**GLASS FITTED TO EDGE OF SQUARE CUPBOARD**

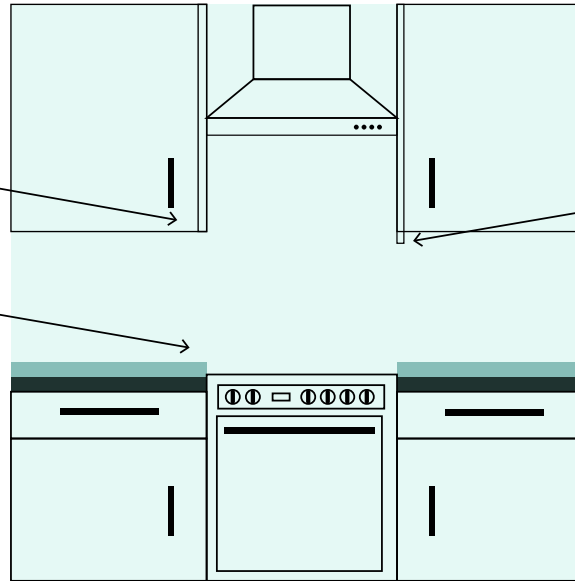
All corners are made using a 18mm diamond router. This leaves a 9mm radius in the corner. If the upstand or cupboard has square corner. You will need to allow 3mm and 2mm gap for tolerance.

**GLASS FITTED OVER UPSTAND**

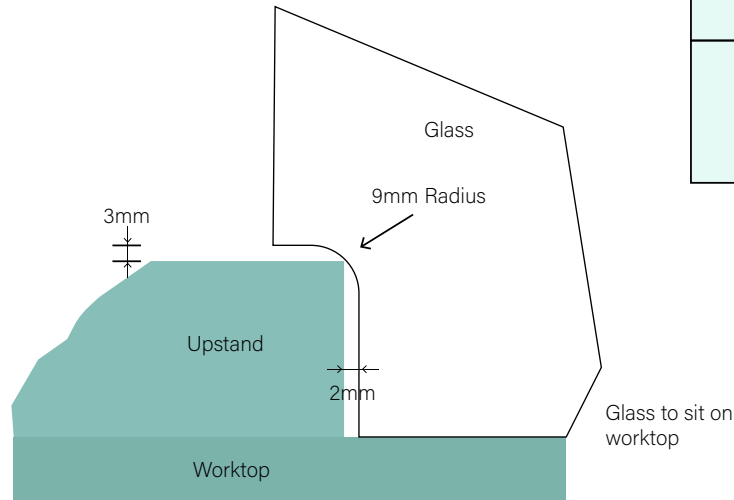
Please allow a tolerance off 3mm in the vertical & 2mm in the horizontal

**GLASS FITTED TO CUPBOARD WITH DROP DOWN END PANEL OR PLINTH**

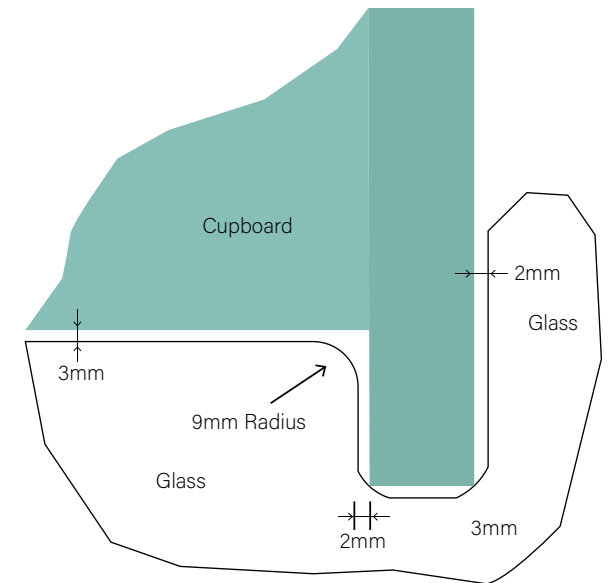
It makes for a better job if side panels and plinths are removed, trimmed and refitted after the glass
